UNITED STATES PATENT AND TRADEMARK OFFICE

APPLICATION NO.	FILING DATE	FIRST NAMED INVENTOR	ATTORNEY DOCKET NO.	CONFIRMATION NO.
09/609,868	07/03/2000	Kenneth Gordon Walker	W2450002	3798

Office Action Summary

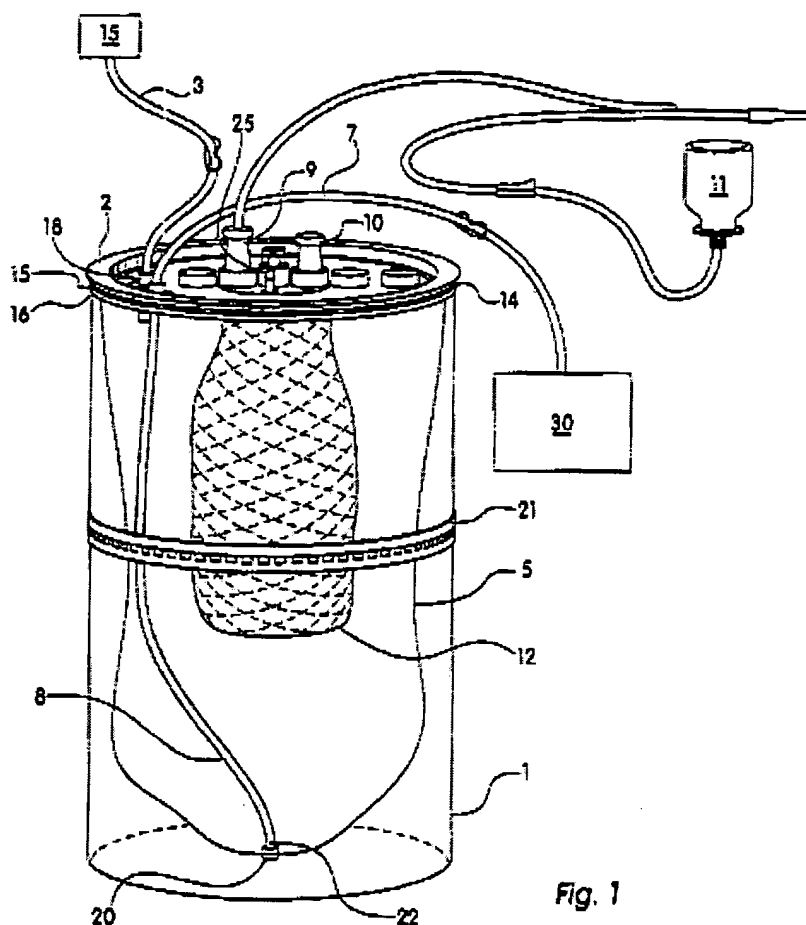
Claims 31 and 36 are rejected under 35 U.S.C. § 102(e) as being anticipated by *Schneider* (5,713,879).

Regarding claim 31, *Schneider* teaches a lid (2) for covering a canister body (1), said lid (2) and canister body (1) together forming a canister for receiving fluids, said canister body (1) having side walls and a bottom, said lid (2) comprising:

an inlet port (9) in said lid (2) for inflow of fluids into said canister;

an outlet port in said lid for outflow of fluids from said canister;

a conduit (8) in fluid communication with said outlet port, said conduit (8) extending to the bottom of said canister body (1) when said lid (2) is placed in covering relation to said canister body (1); and

a vacuum port (18) in said lid (2) for application of vacuum to said canister for inducing flow of fluids into said canister (*see* Fig. 1, below).

It is noted that outlet port is the point in the lid (2) where the outlet tubes (7, 8) meet. It is further noted that parent application No. 09/394,282 to *Schneider* has been reviewed by the examiner and supports all of the elements used in this rejection.

Regarding claim 36, *Schneider* teaches a suction canister, comprising:

a chamber for receiving fluids (1), said chamber being partially defined by a bottom wall;
an inlet (9) communicating with said chamber for the inflow of said fluids into said chamber;

a vacuum port (18) communicating with said chamber for application of vacuum to said chamber;

an outlet communicating with said chamber for outflow of said fluids from said chamber;
and

a conduit (8) in fluid communication with said outlet and extending to said bottom wall of said chamber (*see* Fig. 1, below).
